**INDEPENDENT EXPERT
ADVISORY PANEL FOR MINING**

**HUNTER VALLEY OPERATIONS
CONTINUATION PROJECT
(SSD-11826681 and 11826621)**

July 2024

Advice No: IEAPM 202407-2

Figure 2: Plot showing breakdown of predicted GHG emissions and intensity factors (Figure 4.1 of HVOPL’s Submissions Report (EMM, 2023)).

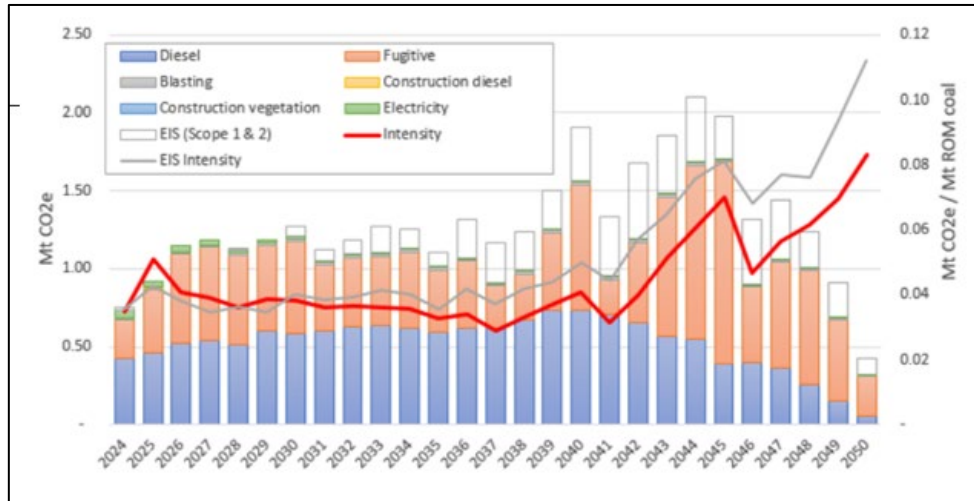
8. From 2042 to 2050, there is over a 200% increase in the emissions intensity factor, notwithstanding that ROM production and associated diesel fuel emissions taper off to zero (Figure 2).

Figure 5: Gas domains within HVO showing the location of gas test boreholes (section lines shown on the figure are not presented in this advice report) (EMM, 2023b)

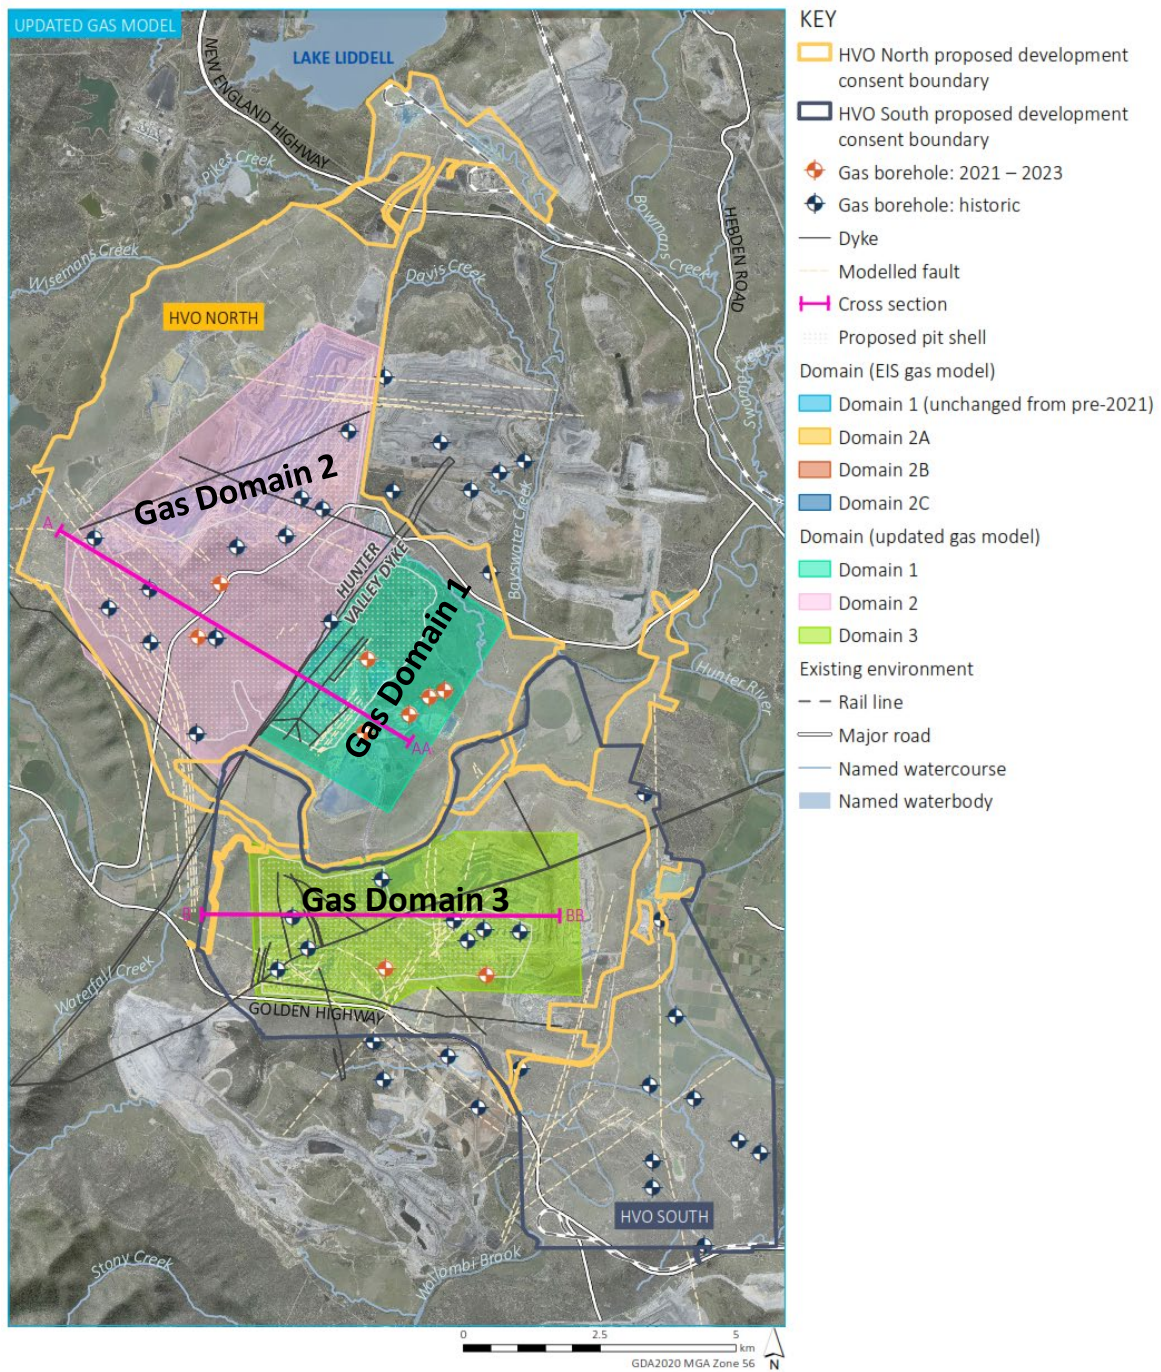
2. The gas content test boreholes drilled northwest of the Hunter Valley Dyke in Domain 2 are all designated as being in a "Low Gas Zone". While regional gas content testing supports the view that the gas content is low in all of Domain 2, there is an approximately 2 km gap between the dense drilling in Domain 2 and the Hunter Valley Dyke, with the borehole adjacent to the north west side of the dyke (see Figure 5) potentially being compromised by heat effects from the dyke. The Panel is of the view that while it is likely the Hunter Valley Dyke is the boundary between Domain 1 and Domain 2, there may be some doubt about the robustness of the gas data derived from the borehole immediately adjacent to the dyke. It is recommended, therefore, that an additional borehole is drilled approximately 400 m northwest of the dyke to ensure quality in gas evaluation.

Figure 6 ROM coal production over the life of the Continuation Project (Figure 4.13 of *Submissions Report* - (EMM, 2023))

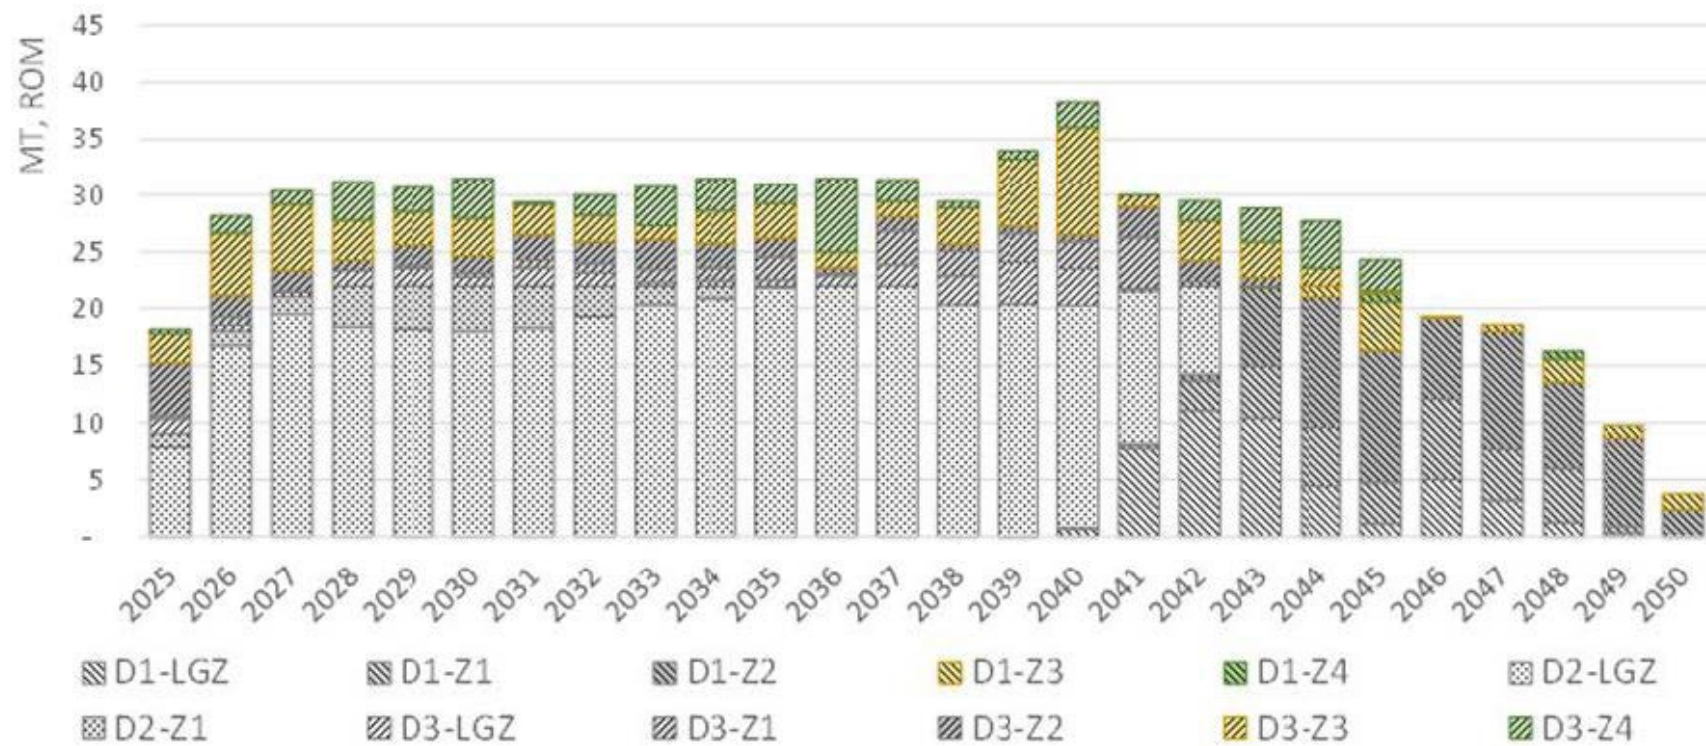
On the basis of the breakdown of sources of annual production and annual fugitive emissions displayed in Figure 6 and Figure 7, the Panel concludes that:

1. The only fugitive emissions avoidance measure available is mine planning that restricts the areal extent of mining and/or the depth of mining.
2. A significant fugitive emissions avoidance measure at HVO would be not to mine Zones 2, 3 and 4 in Domain 1.

3. If Zones 2, 3 and 4 in Domain 1 were not to be mined and the current mine plan was not to be revised, mining would effectively cease at the end by 2044, some 6 years earlier than planned. However, it is possible that mining may cease before that date due to the impacts and consequences of such a decision on the viability of mining just Zone 1.

4. If Zones 2, 3 and 4 in Domain 1 were not to be mined, a revised mine plan may result in the remaining mining in Domain 3 being completed earlier than 2044.

5. If consideration is to be given to these types of options, the options should be put through a mine planning process in order to verify the merits and impacts of the options and properly inform decision making.

1. If modifications are to be made to the mine design for the purpose of avoiding GHG emissions, they should focus on assessing the impacts in Domain 1 of not extracting Zone 2 (low gas concentration but high volume) and/or Zone 3 (high gas concentration and significant volume) and/or Zone 4 (high gas concentration and significant volume).

Figure 7: Breakdown of fugitive emissions by Domain (D) and Zone (Z) over the life of the Continuation Project (Figure 4.14 of *Submissions Report - (EMM, 2023)*)

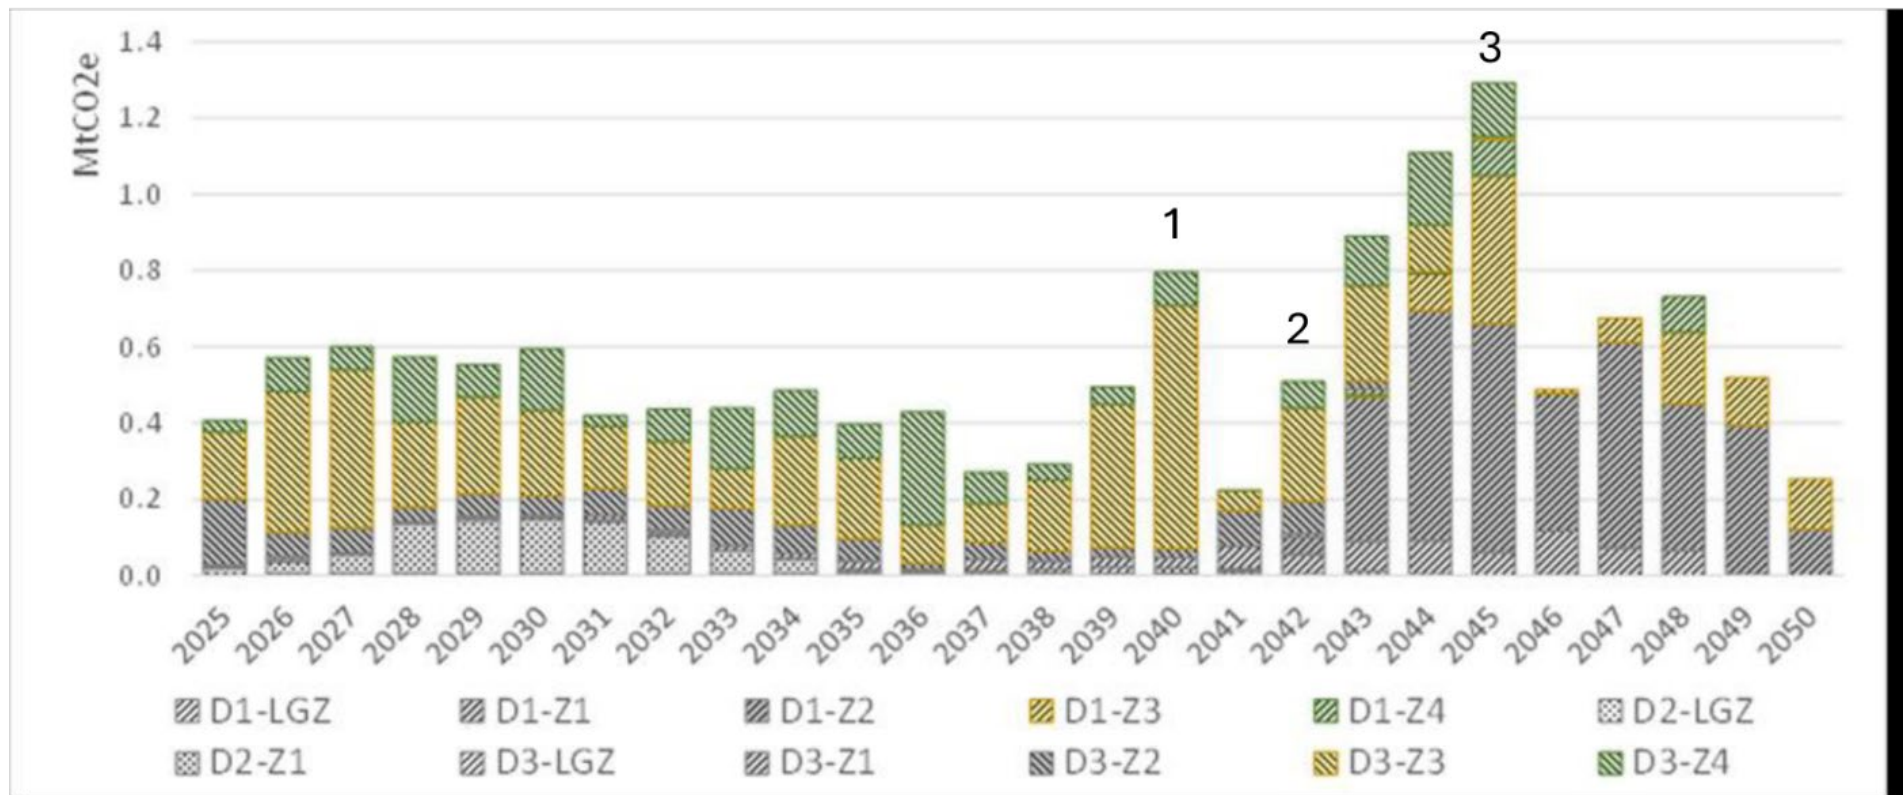
The projected spike in emissions in 2040, labelled '1' in Figure 7, corresponds to predicted ROM coal production peaking that year and to an increased ratio of deeper seams being mined in HVO_South. These deeper seams are associated with higher gas contents in Domain 3 as shown in Table 3.

The projected spike in emissions in 2042, labelled '2' in Figure 7, corresponds to when mining in HVO North starts to progress into the methane dominated seams in Domain 1. By 2045, all mining in HVO North is scheduled to occur in Domain 1, accounting for the spike in fugitive emissions, labelled '3'. Here there is both an increase in emissions in Zones 3 and 4 and significant emissions from the less gassy Zone 2.

1. Zones 2, 3 and 4 in Domain 1 all contain significant proportions of CH₄ (Table 3).
2. Zone 2 has a low gas content (2.5 m³/t, Table 3) but a high gas volume (Figure 7).

3. Due its low gas content of 2.5 m³/t, it is unlikely that Zone 2 is suitable for pre-drainage.
4. Zone 3 and Zone 4 have high gas contents (6.1 m³/t and 4.4 m³/t, respectively, Table 3) but each zone contains typically less than half the gas emissions of Zone 2 (Figure 7).

5. Zone 3 and Zone 4 have potential for gas-drainage (discussed in more detail in Section 4.2.7).
6. From 2043 forward, Zone 2 accounts for at least 50% of annual CO₂-e fugitive emissions (Figure 7).

7. From 2043 forward, the annual CO₂-e fugitive emissions from Zone 2 alone are of a similar magnitude to annual CO₂-e fugitive emissions of the Continuation Project up to that point in time (Figure 7).

Based on Figure 7, the Panel has calculated that 30% to 50% pre-drainage of Zones 3 and 4 in Domain 3 would result in a reduction of GHG emissions to the atmosphere of 17% to 34%, assuming complete combustion of CH_4 if implemented successfully from the start of the Continuation Project.
